# LAKE HAVASU CITY, ARIZONA

## ADDENDUM NO. 1

### Lake Havasu & Mesquite Avenue Paving Rehabilitation

Project No: B25-PW-106017-500586

Sheet Number:  
**WT01**  
Sheet 20 OF 32

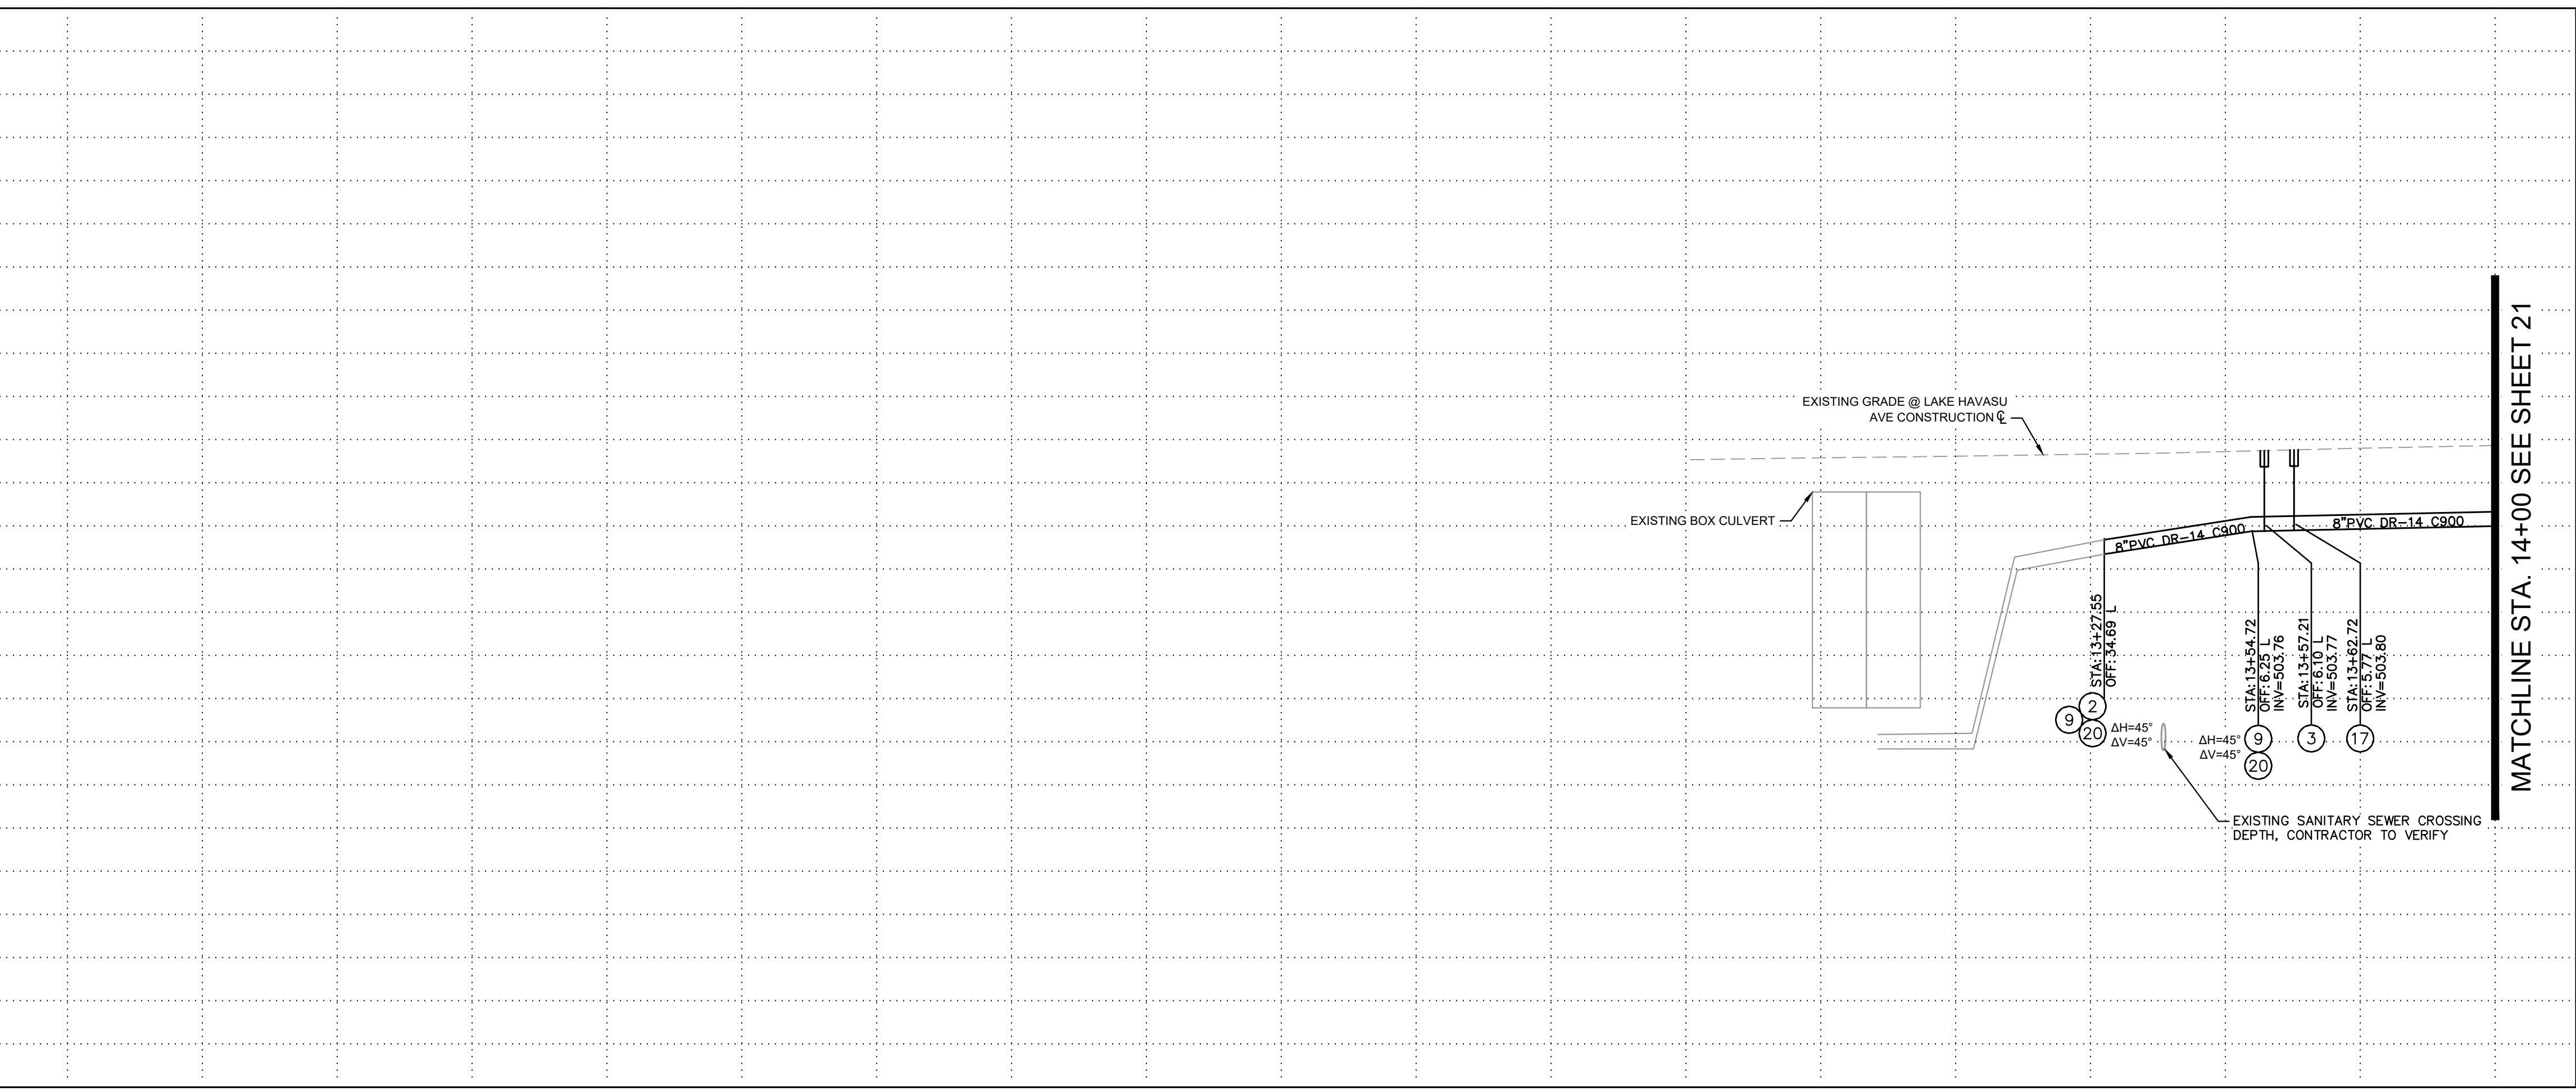
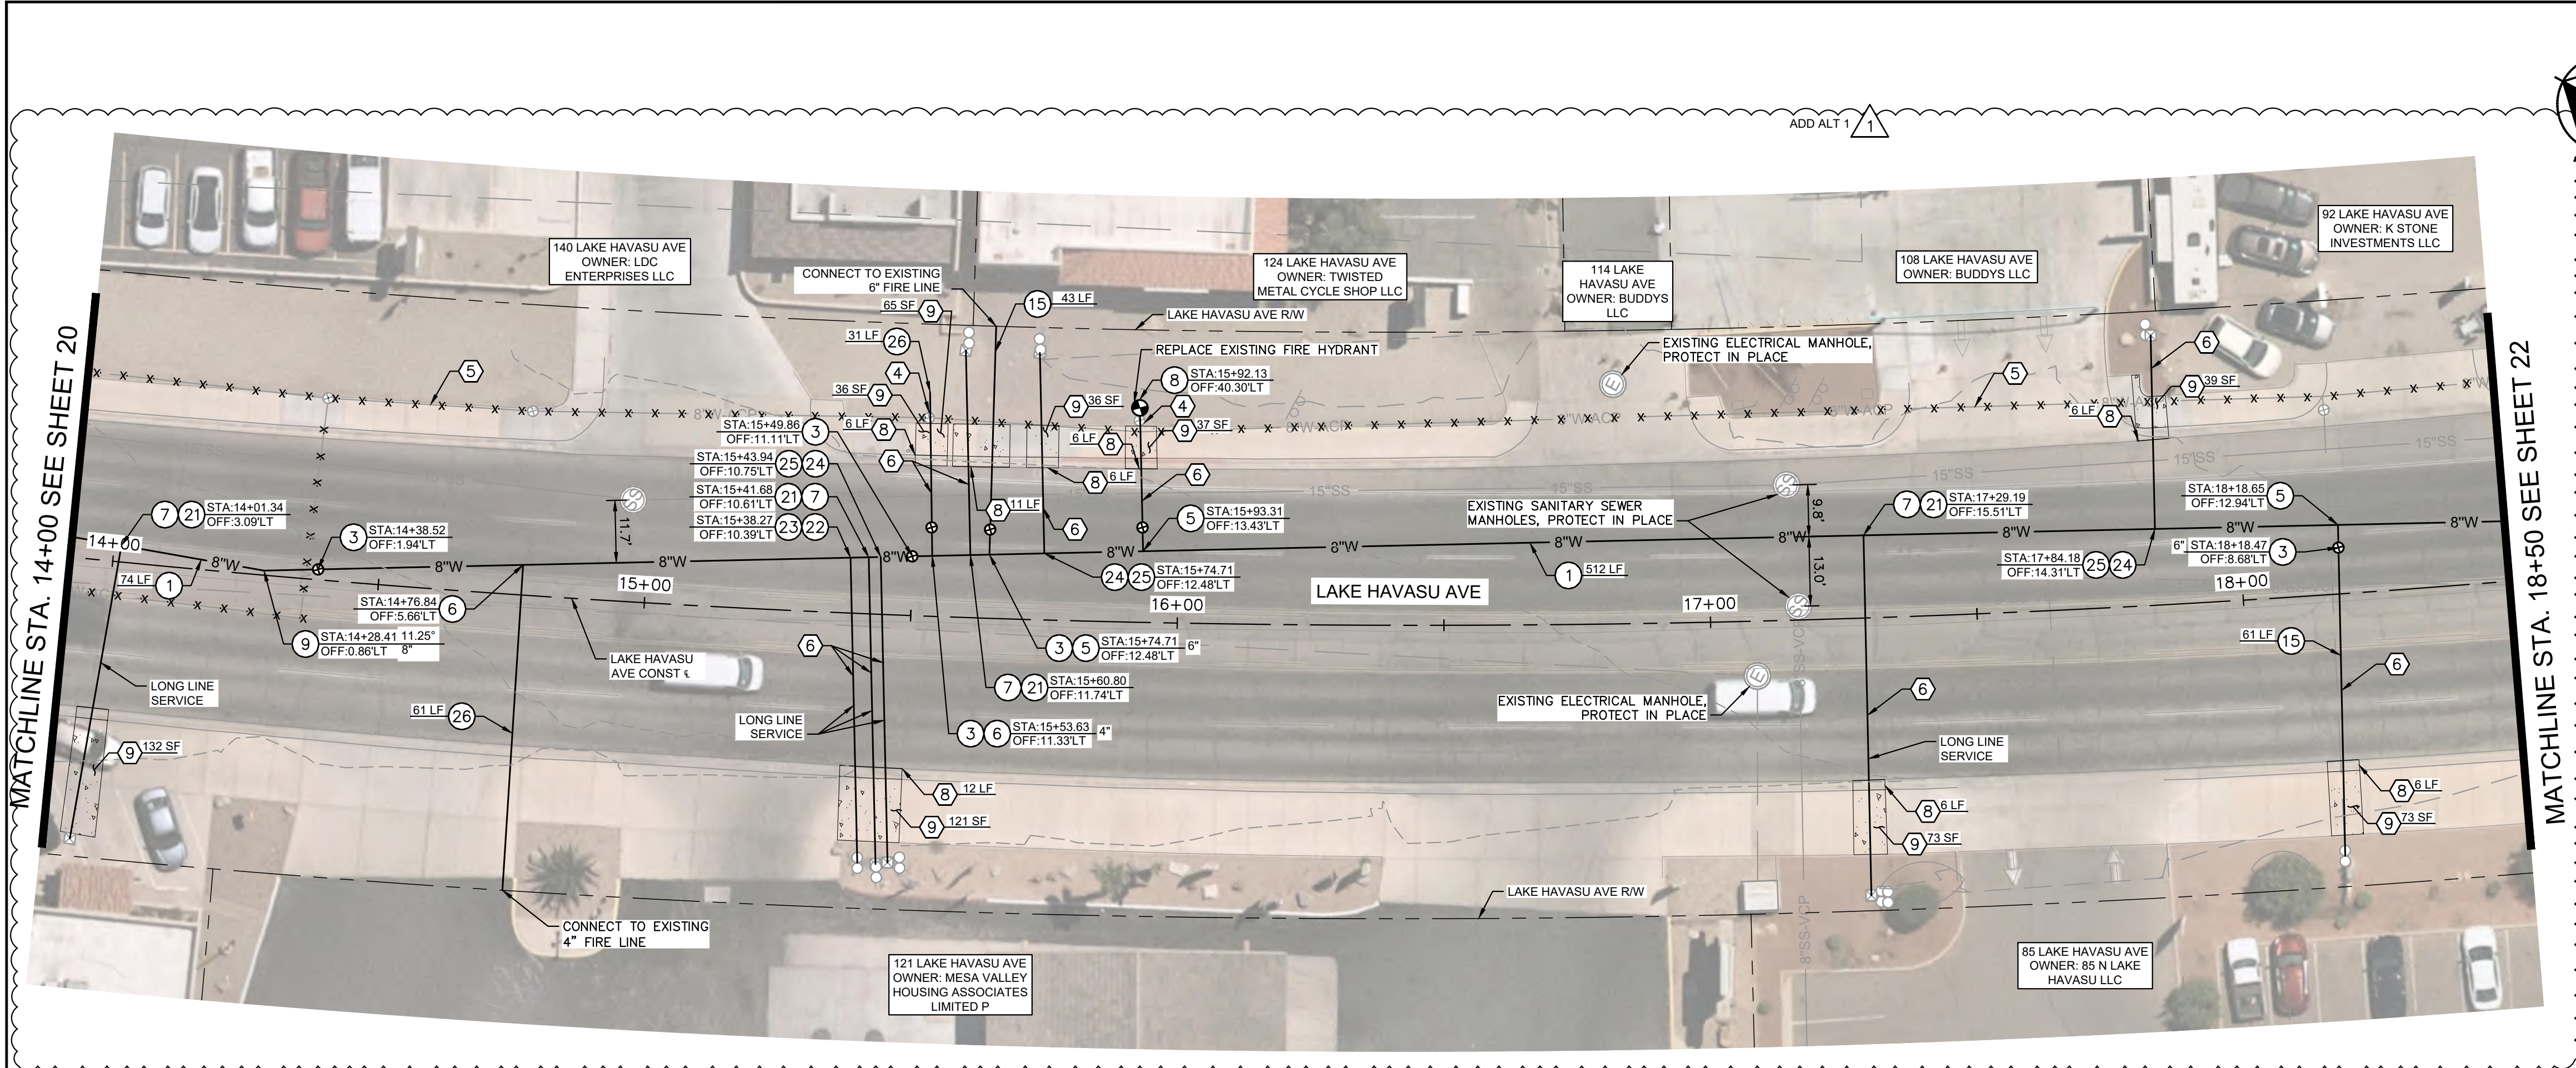
- Improvements have been identified as part of Bid Alternate 1.

1 ADD ALT 1  
 REMOVE WATER MAIN IMPROVEMENTS & PAVING LAKE HAVASU AVENUE

NO.	REVISIONS / SUBMISSIONS	DATE
1	BID ALTERNATE 1	10/29/2024
#	-	-
#	-	-
#	-	-

**WATER PLAN & PROFILE - MESQUITE AVE STA 161+50 TO 166+00**

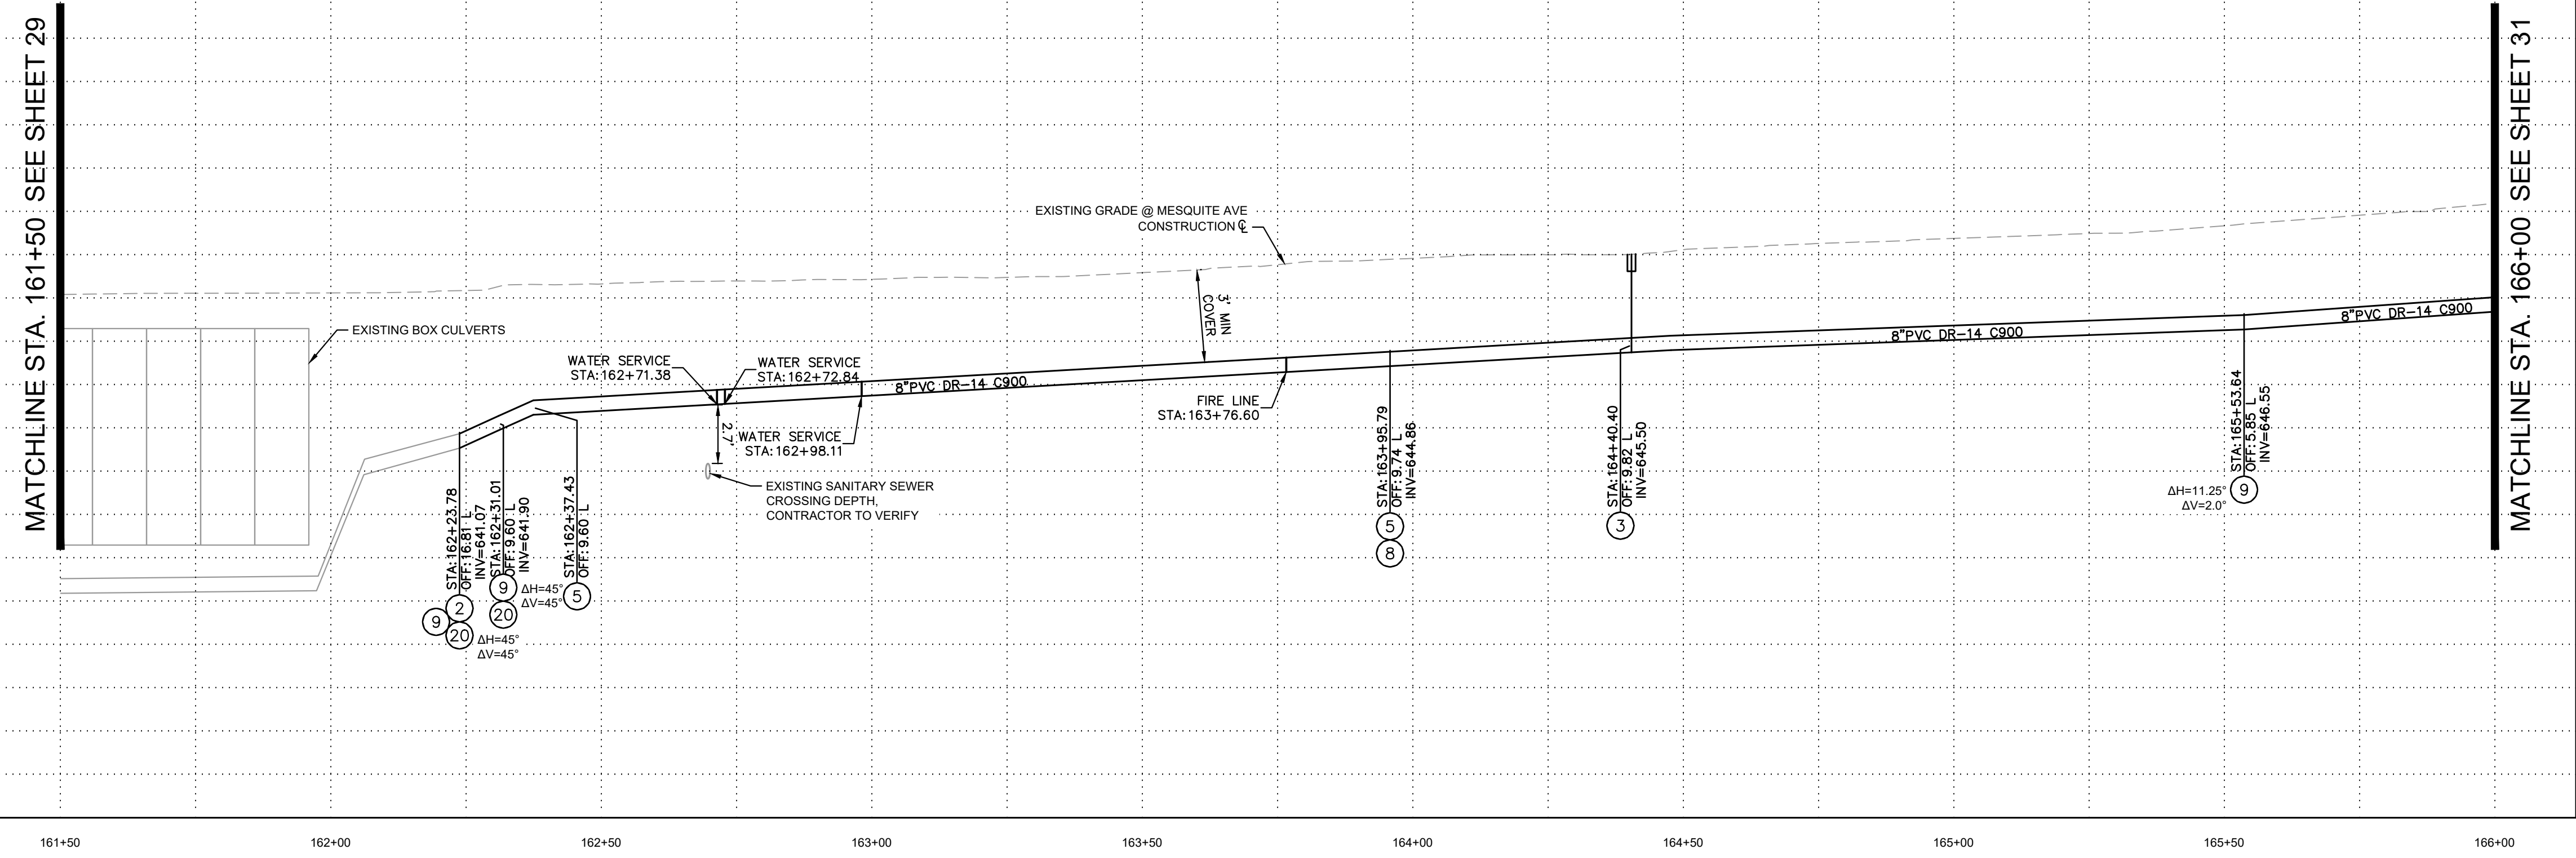
- Improvements have been identified as part of Bid Alternate 2.

ADD ALT 2  
REMOVE WATER MAIN IMPROVEMENTS MESQUITE AVENUE, PIMA WASH TO ACOMA BLVD.

NO.	REVISIONS / SUBMISSIONS	DATE
2	BID ALTERNATE 2	10/29/2024
#	#	#
#	#	#
